Metropolitan Planning Commission

Staff Reports

March 8, 2010

2004UD-002-001
 Villages Of Riverwood, Sect. 1, Ph. 2
 Map: 097-00 Parcel: 158
 Donelson/Hermitage/Old Hickory Community Plan
 Council District 14 – James Bruce Stanley

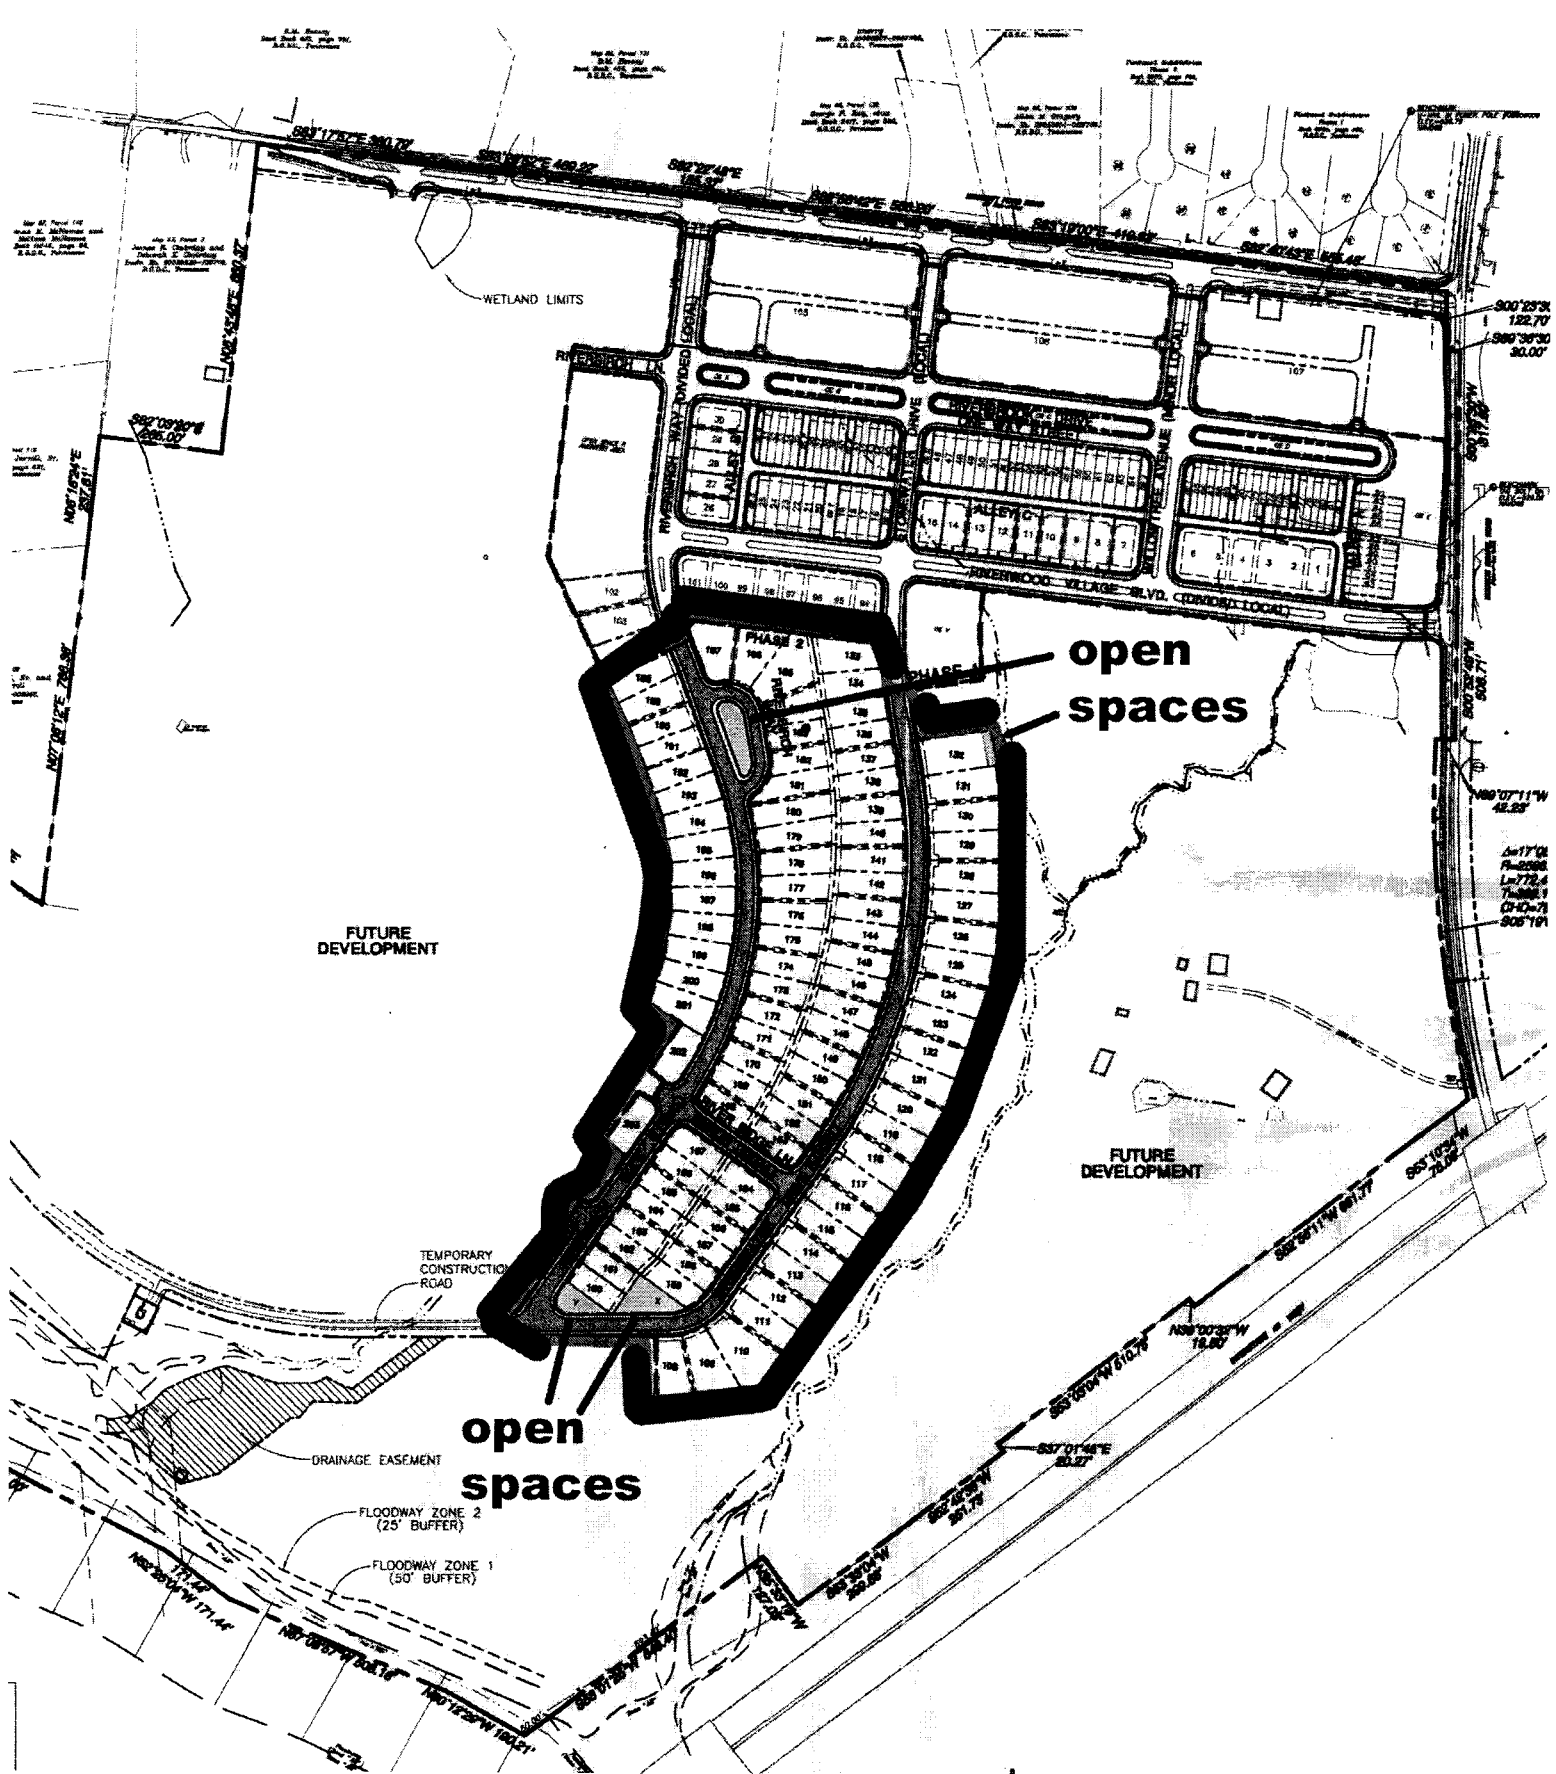
The final site plan also conflicts with a previous final site plan approval within the Villages of Riverwood UDO. On June 12, 2008, the Metro Planning Commission approved a final site plan on adjacent land for 418 apartment units. Included in that final site plan was a trail connection to Stonewater Drive. Stonewater Drive is included in Section 1, Phase 2 but the trail connection is not shown on the currently proposed plan. As a result, approval of this final site plan would be in conflict with the previous approval. Staff recommends that the applicant include the approved trail location in the current proposal to allow for a continuous trail system throughout the UDO, as was originally approved by Council.

1. Please remove the text "Approved Stormwater Appeals for Buffer Encroachment #2006-126" from the plans as the variance does not apply to this development.
2. Provide separate Initial Erosion Control Plan Sheets showing only existing contours and conditions with initial erosion control BMPs. Include the proposed

3. The sediment traps drainage areas are not indicated. According to the contours, much of the proposed area runoff will bypass the rectangular sediment traps. Please delineate on a separate Site Sketch the proposed areas draining to the sediment traps.

7. Provide Ditch sizing calculations. Show 10-year storm event elevations with at least 6-inch freeboard. Show the extent of ponding due to the check dams and the inlet pipe shown on Lots 153 and 180. Advise replacing the ditch with stormwater conduit.

10. Provide a 1-foot freeboard above the proposed 100-year elevation (454.95) in the pond. Set the emergency overflow weir at the proposed 100-year elevation.

11. Provide a minimum 2% bottom slope in the pond bottom to the permanent pool.
12. More than half of the lots along Stonewater Drive and Lots 200, 201, 202, and 203 on Riverbirch Way do not drain to the stormwater system. It unlikely residences will be built in the lot area draining to the stormwater system. The system is to include the developed lot covered by the residential structures and any other impervious structures.

Staff recommends disapproval. The proposed final site plan significantly degrades usable open space and is not consistent with either the approved preliminary Villages of Riverwood Urban Design Overlay or the adjacent final site plan approved by the Metro Planning Commission in June 2008.

**Approved
Plan**

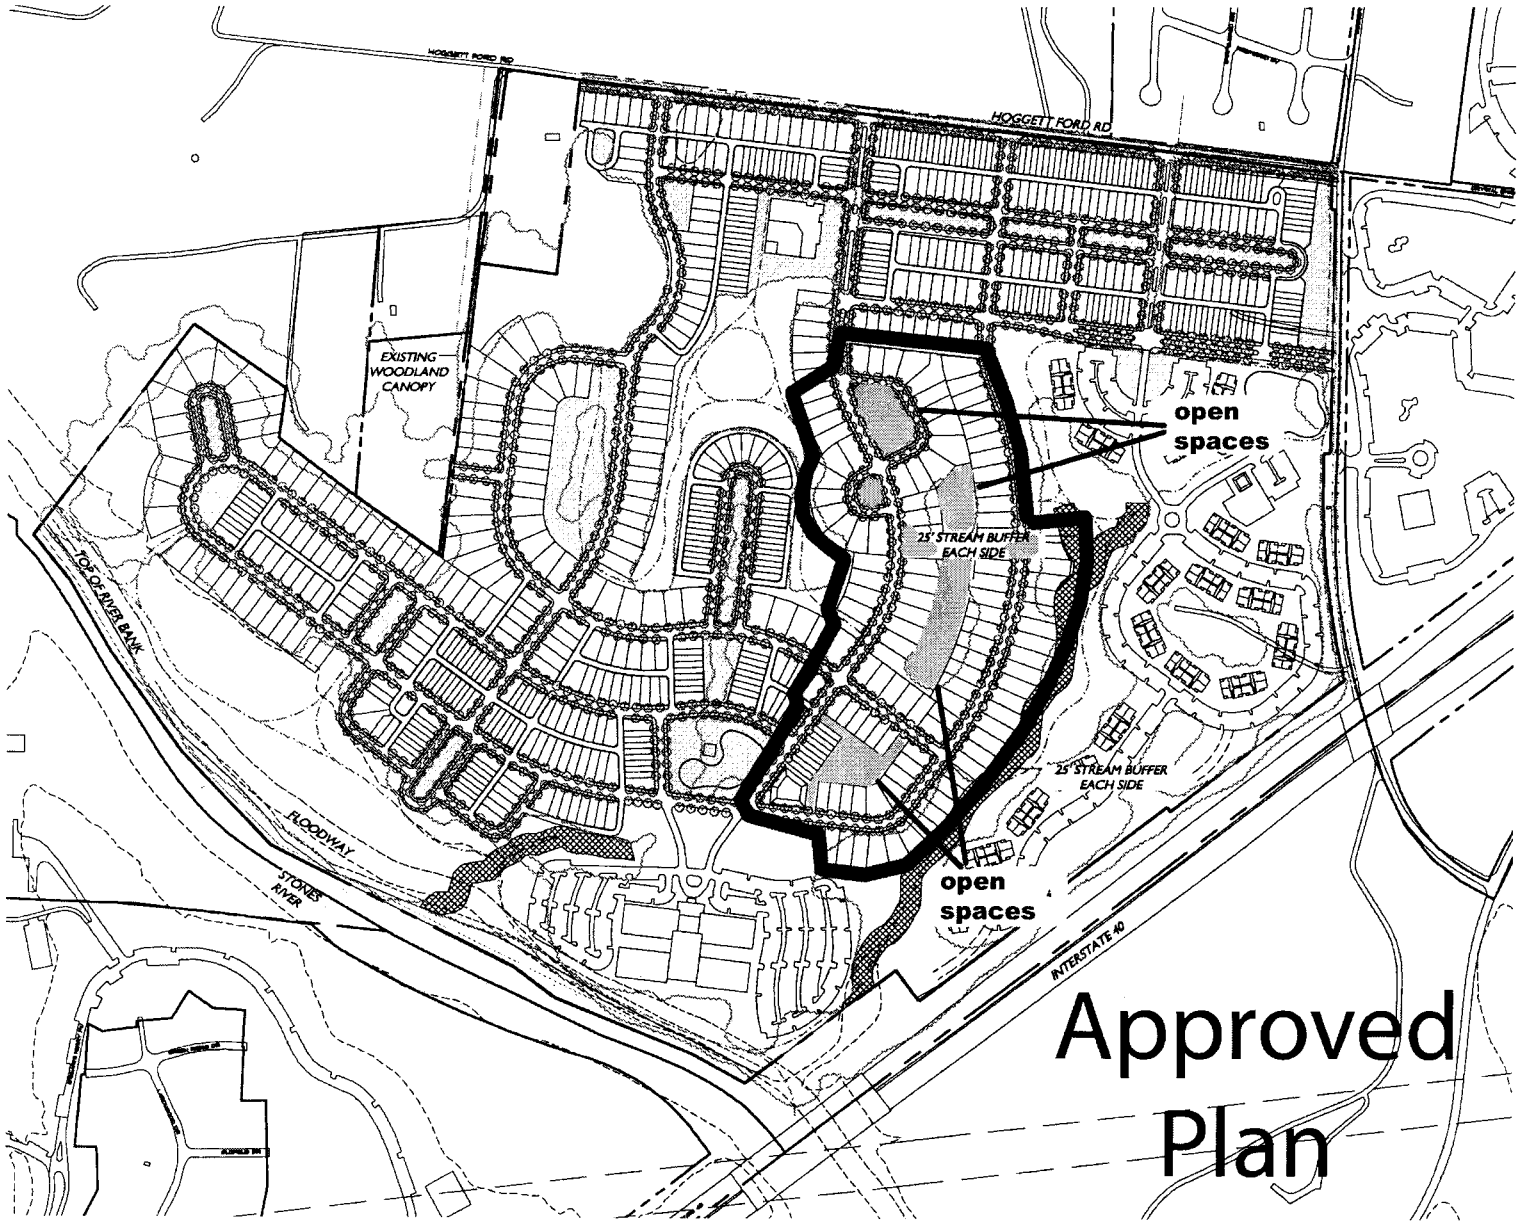
The final site plan request is not consistent with the preliminary UDO in the layout, quality or purpose of the open spaces. Approximately 0.5 acres of open space is proposed within this phase and is dispersed among four separate areas. On the proposed plan, Open Space area W is a 6,526 square foot space located within Riverbirch Way in the northern portion of the proposal, dividing the street into two segments for a distance of approximately 250 feet. With dimensions of 160 feet in length and 48 feet to 65 feet in width, this space will be a visual focal point for 12 lots with limited scope as a usable open space area. On the approved preliminary plan, this open space area was larger with more generous dimensions that would allow it to serve as usable space and limited active open space.

Open Space areas X and Y are located at the southern end of this section within an interior block. These open spaces are remnant areas caused by the irregular shape of the block. On the preliminary plan, this block included a consolidated open space at its interior. As proposed, these spaces will provide limited benefit to the surrounding neighborhood because of their irregular shape and lack of continuity.

Open Space area Z is located behind Lot 132 in the northeast corner of the section. It is the smallest proposed open space with approximate dimensions of 20 feet by 80 feet. Its size and location away from the street will eliminate its viability as a useable open space and make it indistinguishable from the backyard of Lot 32.

The preliminary approval included two additional open space areas that do not have an equivalent in the current proposal. There was a second open space within Riverbirch Way and a linear open space in the northern block of this section. These are not shown in the proposed final site plan.

1. Comply with all conditions of the original council bill (BL2004-325).
2. Comply with all NES, Fire Marshal, Water Services, and Stormwater conditions.
3. Revise the site plan for Section 1, Phase 2 reflecting the previously approved trail location.
4. The character, quality, and utility of open spaces in the approved UDO plan shall be restored in the final site plan.
